**BROWNS FERRY NUCLEAR PLANT (BFN) - UNIT 3 - AMERICAN SOCIETY
OF MECHANICAL ENGINEERS (ASME) SECTION XI, INSERVICE
INSPECTION PROGRAM, SECOND TEN-YEAR INTERVAL, REQUEST FOR
RELIEF 3-ISI-10 (TAC NO. MB1773)**

TENNESSEE VALLEY AUTHORITY
BROWNS FERRY NUCLEAR PLANT (BFN)
UNIT 3
AMERICAN SOCIETY OF MECHANICAL ENGINEERS (ASME) SECTION XI,
INSERVICE INSPECTION (ISI) PROGRAM
(SECOND TEN-YEAR INSPECTION INTERVAL)

REQUEST FOR RELIEF 3-ISI-10

Browns Ferry Unit 3, Stud Details RPV Closure Head, drawing SK-B3037

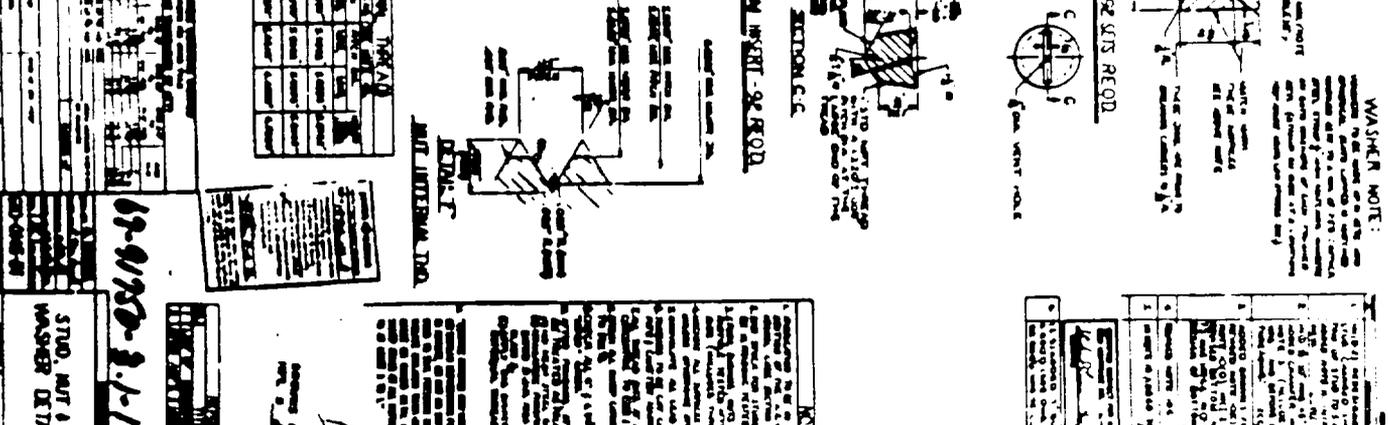
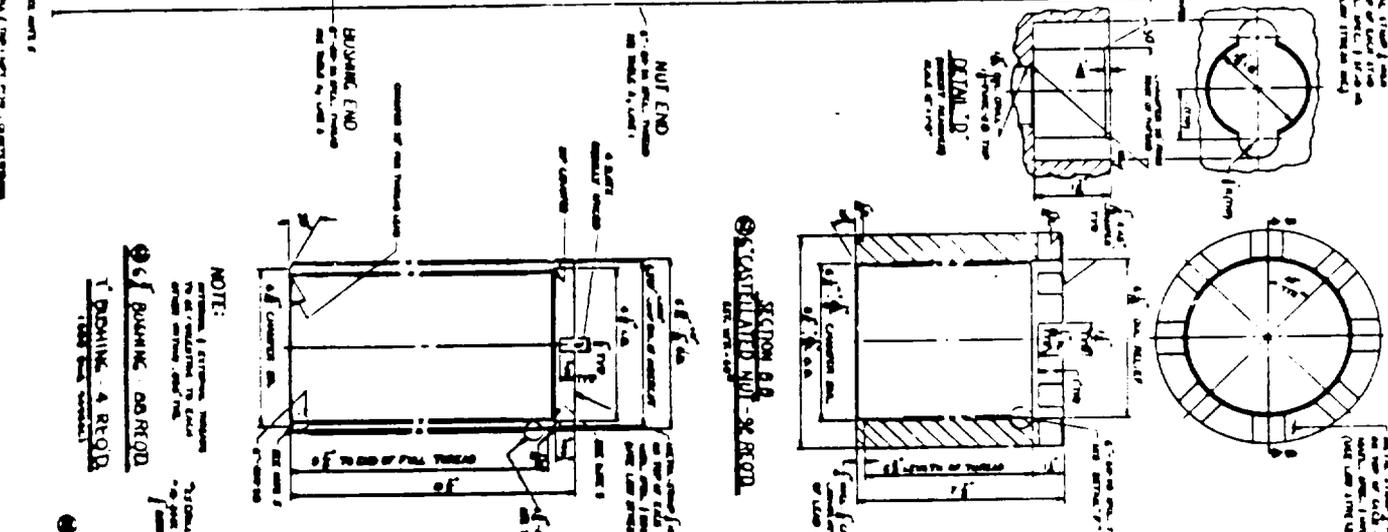
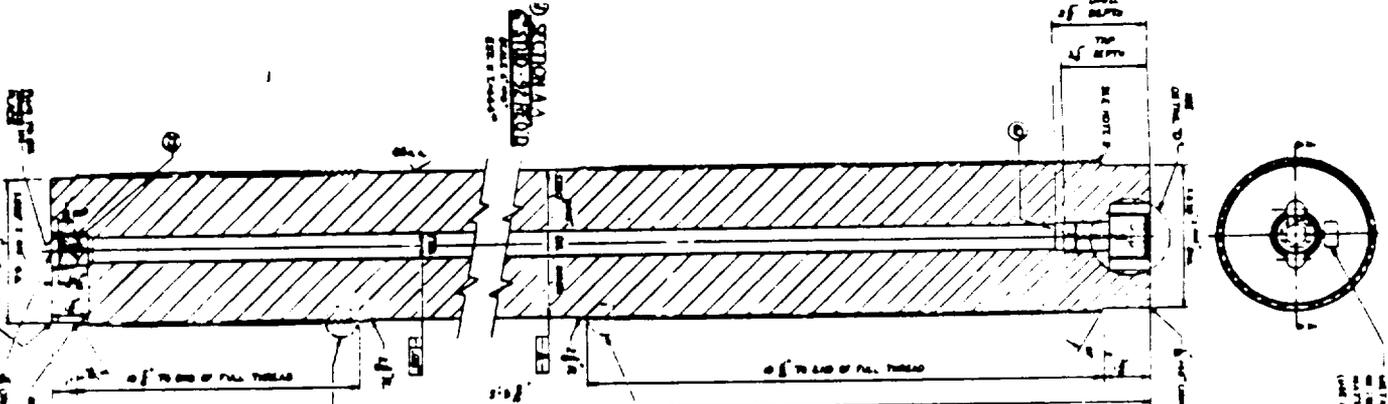
Code Requirements From Which Relief Is Requested: Relief is requested from the requirement to perform a surface examination of the RPV closure head nuts, as stipulated in ASME Section XI, 1989 Edition (no Addenda), Table IWB-2500-1, Examination Category B-G-1, Item B6.10.

Extensive cleaning of the RPV Nuts is required prior to performing the wet fluorescent magnetic particle examination. This extensive cleaning results in an additional expenditure of resources, and an increased radiological dose for examination personnel.

Due to design factors, the stripping areas of the female threads (i.e., inside the nut) are approximately 1.3 times the area of the mating male threads (see ASME B1.1, Unified Inch Screw Threads). Consequently, if a defect were to develop during component service, the defects should occur in the threads of the bolt or stud before developing in the threads of the nut because of higher stresses in the male

threads. Also, when RPV closure head nuts are tightened for closure or loosened for opening, the studs are tensioned and the nuts are run on/off the threads with no load since the load is taken by the stud or bolt through the tensioning device.

TVA will perform a visual (VT-1) examination of the RPV closure head nuts in accordance with the requirements of the 1995 Edition with the 1996 Addenda of ASME Section XI, Table IWB-2500-1, Examination Category B-G-1, Item B.6.10. TVA considers that its proposed alternative provides an acceptable level of quality and safety.
